THE COUNTY OF CHESTER

PLANNING COMMISSION

Re: Conditional Use – The Robinson Tract
Westtown Township - CU-09-19-16071

A Conditional Use Plan entitled "The Robinson Tract", prepared by ESE Consultants, Inc., and dated August 9, 2019, was received by this office on September 19, 2019. Although our review is not required by Act 247, the Pennsylvania Municipalities Planning Code as amended, our comments are offered as a planning service at the request of Westtown Township. This review does not replace the need for an official referral by Westtown Township of a preliminary or final subdivision plan, as required by the Pennsylvania Municipalities Planning Code.

Figure 2: Site Plan Detail, Sheet 12, Conditional Use Application, The Robinson Tract

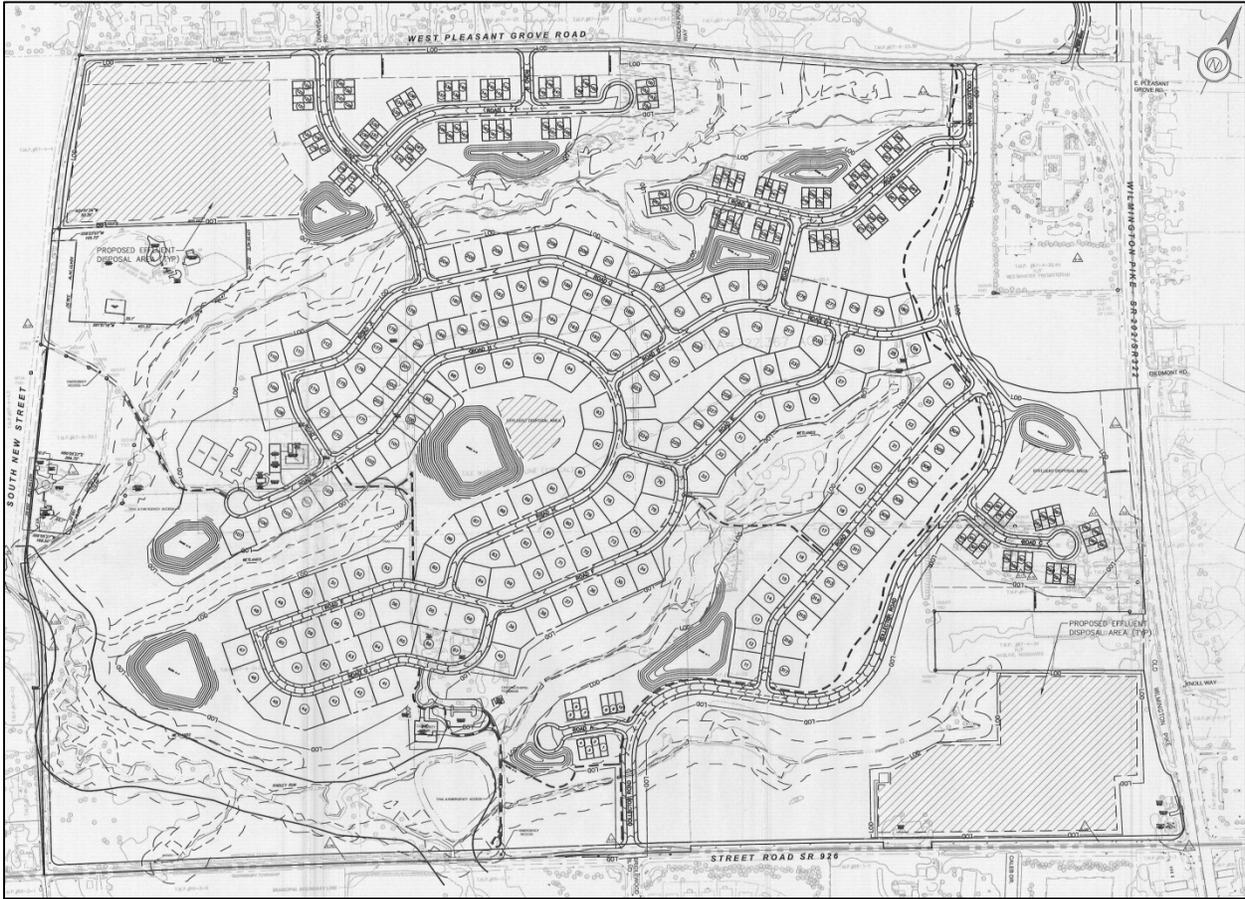
24. While Sheet 12-Overall Lot Layout provides a brief list of the tract area, proposed density and proposed impervious coverage of the development, it does not provide a zoning compliance table. This should be clarified by the applicant.

Figure 4: Chester County Planning Commission's conceptual illustration of development on the Robinson Tract (December 7, 2016)

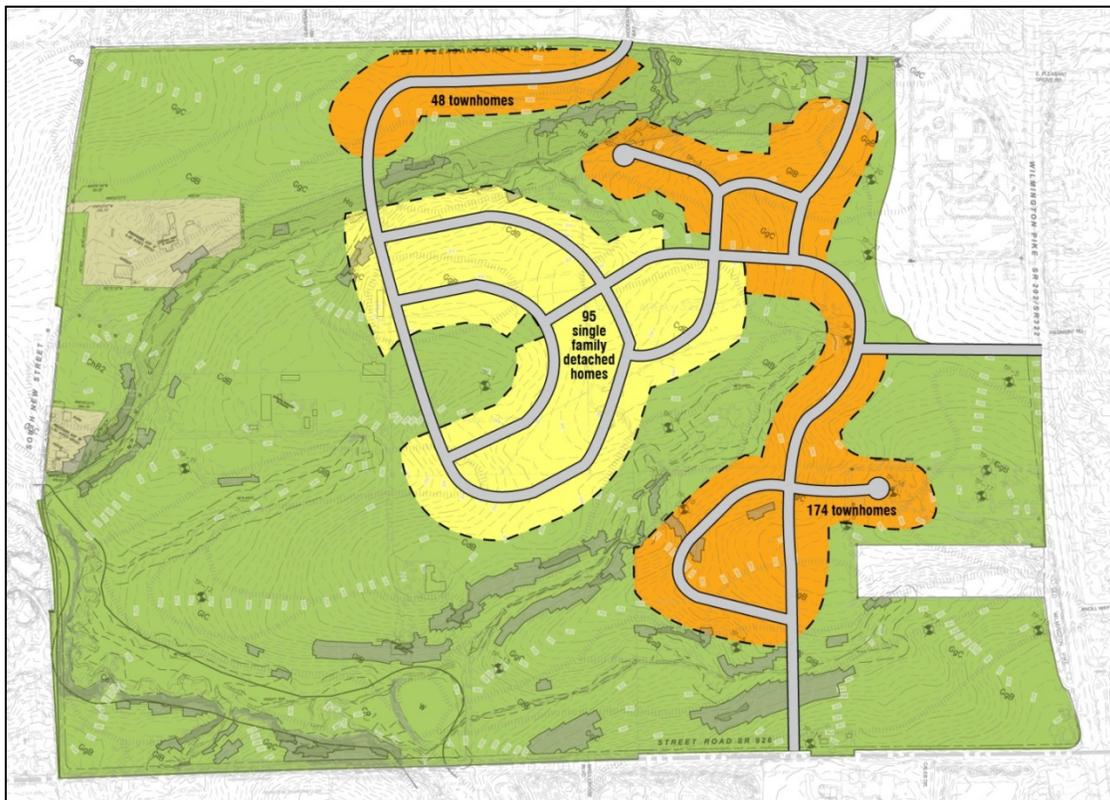
Figure 4, which was also provided in our previous review letter, provides a conceptual illustration of how development activity on the Robinson Tract can be located outside of the majority of the Rural Landscape and Brandywine Battlefield area. The County Planning Commission would be happy to work with the applicant and the Township on alternative sketch plans of the site that have a higher proportion of townhomes, along with more open space provided on the portion of the tract located in the Rural Landscape.
